SYDNEY CENTRAL CITY PLANNING PANEL COUNCIL ASSESSMENT REPORT

Panel Reference	PPSSCC-6
DA Number	DA/351/2019
LGA	City of Parramatta
Proposed Development	Demolition and construction of a multi dwelling housing development containing 29 townhouses over basement parking pursuant to the Affordable Rental Housing SEPP 2009. The application will be determined by the Sydney Central City Planning Panel.
Street Address	178-188 Pennant Street, North Parramatta, NSW 2151
Applicant	North Parramatta Community Pty Ltd
Owner	NSW Land & Housing Corporation
Date of DA lodgement	13 June 2019
Number of Submissions	One (1) submission received
Recommendation	Deferred Commencement – Approval
Regional Development Criteria	Crown development with a capital investment value of more than \$5 million. (\$11,514,398)
List of all relevant s4.15(1)(a) matters	<ul style="list-style-type: none"> • Environmental Planning and Assessment Act 1979 • Environmental Planning and Assessment Regulation 2000 • State Environmental Planning Policy No. 55 – Remediation of Land • State Environmental Planning Policy (Building Sustainability Index: BASIX) 2004 • State Environmental Planning Policy (Vegetation in non-rural areas)

Figure 18: Assessment demonstration of one of the development's proposed building. Approximate required roof form envelope of 45° is highlighted in blue and protrusion is highlighted in yellow.

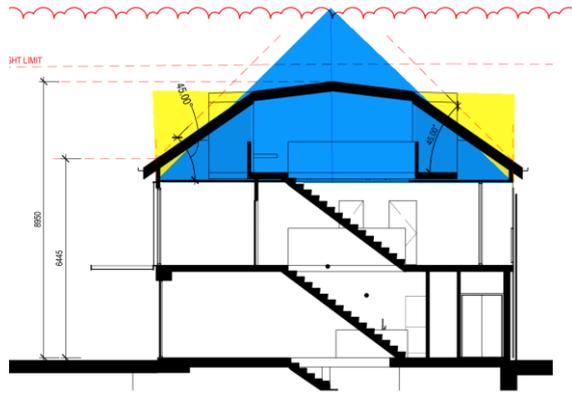
3.2 Building Elements		
<u>3.2.1 Building Form and Massing</u>	The bulk and scale is suitable for the site.	Yes
<u>3.2.2 Building Facades Articulation</u>	The proposed development consists of recognisable entries, a mix of building materials and colours, and does not contain large areas of blank or poorly articulated walls.	Yes
<u>3.2.3 Roof Design</u> <i>Multi Dwelling Housing</i> Roof forms are to be contained within a building envelope determined by projecting a plane at 45° from the ceiling level of the uppermost storey (applying to all elevations of the building), to a maximum height of 11m for two storey buildings and 8m for single storey buildings.	All of the proposed roof forms protrudes past the extent of the 45° envelope <u>measured from the uppermost storey's finished ceiling level</u> at all elevations of all buildings proposed. All dormer windows proposed will protrude outside of the permissible envelope.	No , however the non-compliance is acceptable.

The proposed development has been reviewed by Council's Design Excellence Advisory Panel, and has been endorsed by Council's City Architect. Council's City Architect had stated that the proposed development is of a high architectural quality and that the contemporary form and gambrel roofline is supported. The non-compliance is acceptable in this regard.
